Application of button tie on breather hoses

Panigale V4 Model Year 2018-2020 (all versions)
Panigale V4 R Model Year 2019-2020
Service Repair Bulletin SRV-SRB-20-024

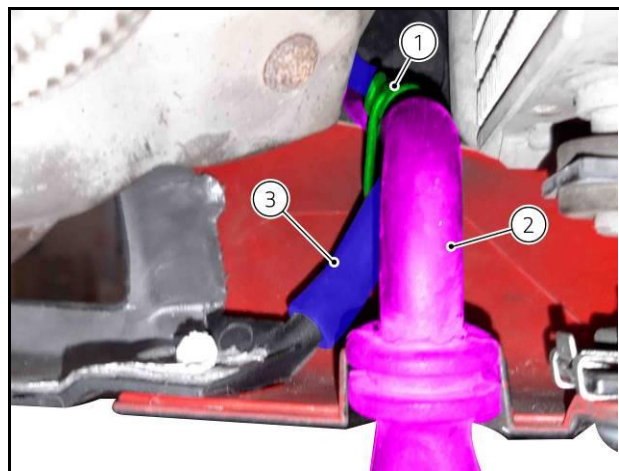
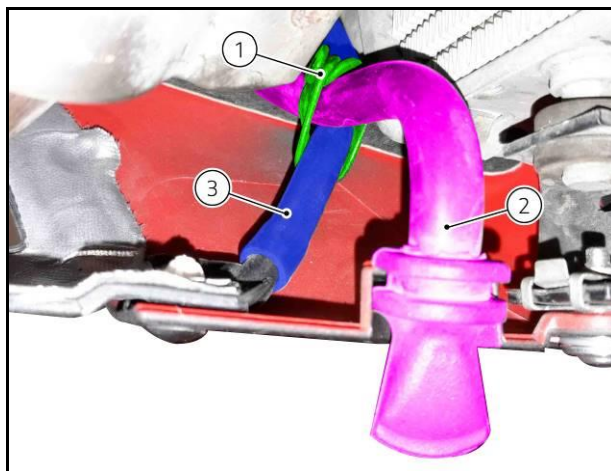
Due to ongoing checks of field service and repairs, we have identified a pattern of improper reinstallation of drain hoses during the reassembly of the lower fairings after routine service procedures. To ensure proper reinstallation, we have introduced the application of a button tie to fasten the Airbox drain hose to the fuel-coolant tank breather hose in the lower area of the left fairing.

This additional tie is to avoid incorrect positioning of the hoses during the reassembly of the left side fairing. For example, after a service or repair operation and during the reassembly of the fairing, these hoses could have been positioned incorrectly which could possibly interfere with the heat guard of the exhaust manifold.

For all motorcycles manufactured from May 2020 onwards, we have introduced a L=39mm **button tie (1)**, part no.74110551A, to fasten the Airbox drain **hose (2)** to the fuel-coolant tank breather **hose (3)**, as shown in the figure.

During the scheduled maintenance operations or upon the first workshop service, for all Panigale V4 models, please check the position of the breather hoses in the side fairing lower connection area and install the L=39mm button tie if it is not present.

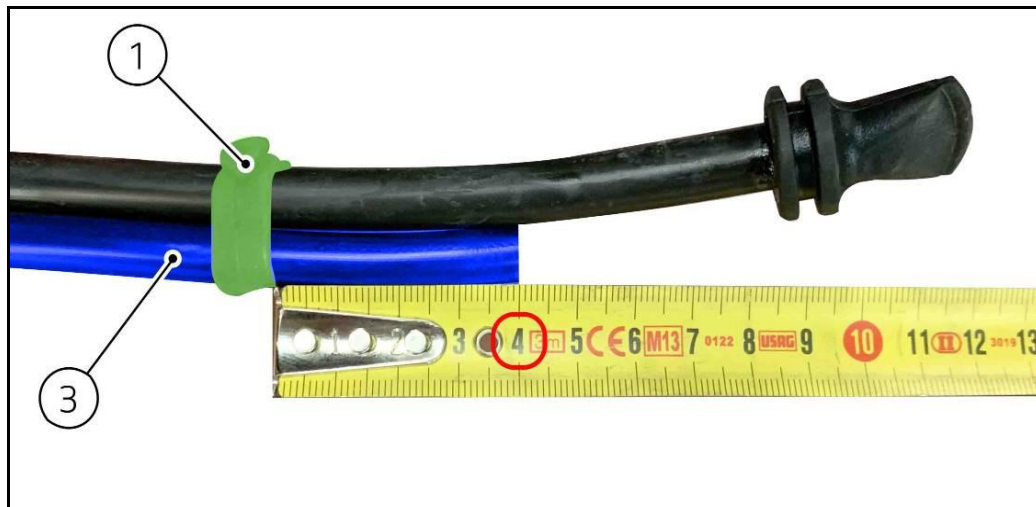
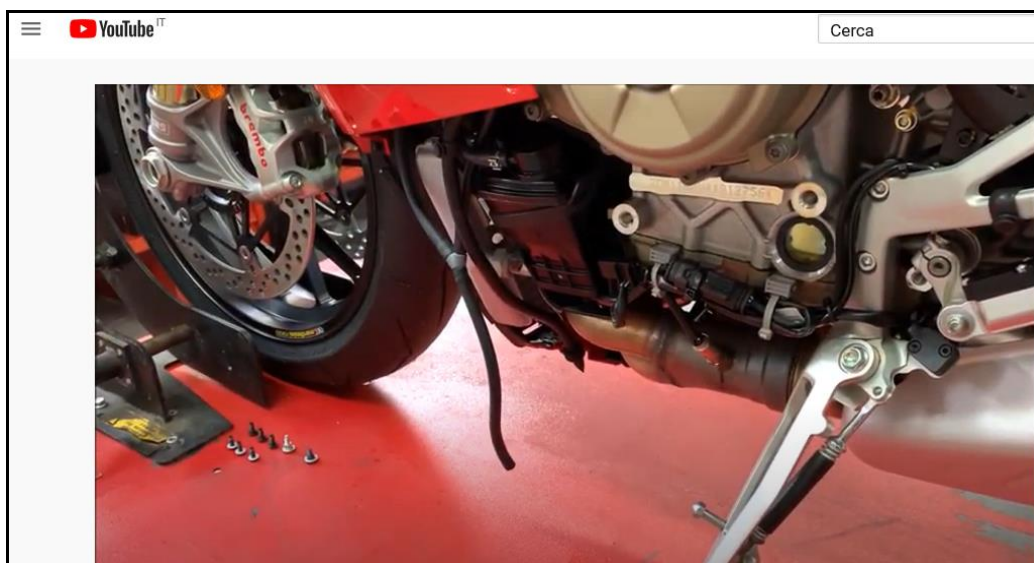
The L=39mm **button tie (1)** is positioned at a distance of 4 cm measured from the lower end of the fuel-coolant tank breather **hose (3)**, as shown in the figure.

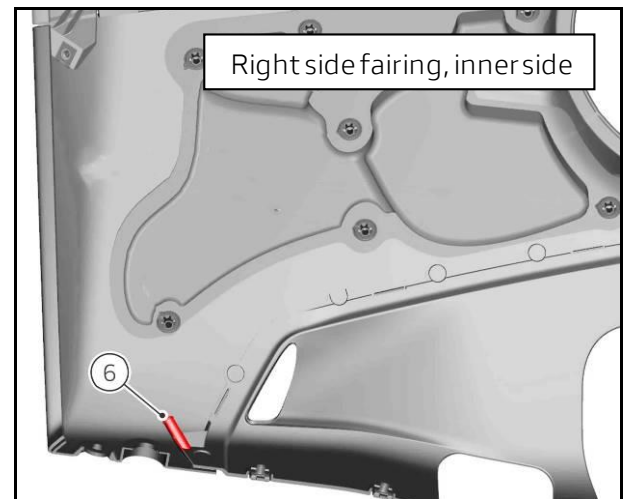
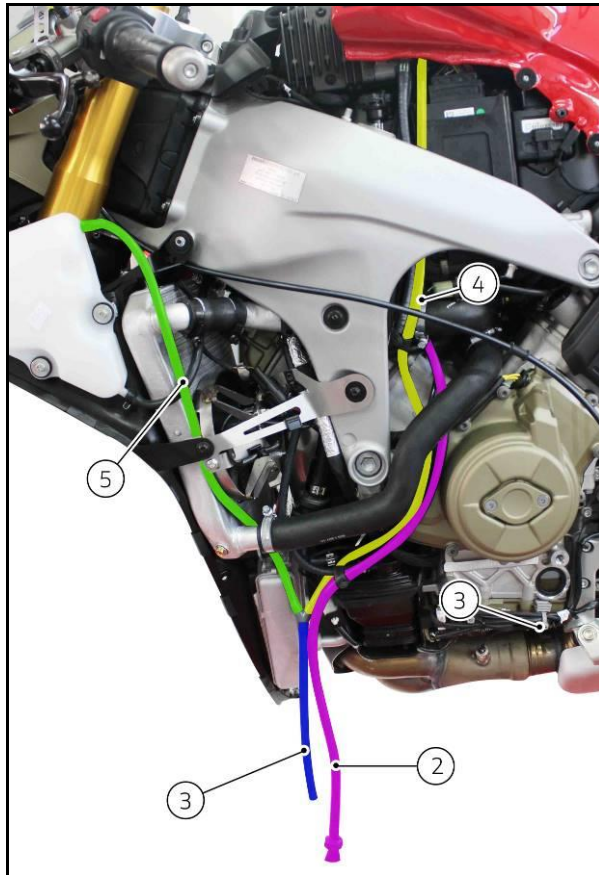
Upon assembly, ensure the proper routing of the following is maintained along the left side of the motorcycle and that **union (6)** inside the lower right fairing silencer cover remains free, as shown in the figure:

- airbox drain **hose (2)**
- fuel tank breather **hose (4)**
- coolant breather **hose (5)**
- fuel-coolant tank breather **hose (3)**

During the scheduled maintenance operations or upon the first workshop service, please check the position of the breather hoses in the side fairing lower connection area and to install the L=39mm button tie if it is not present.
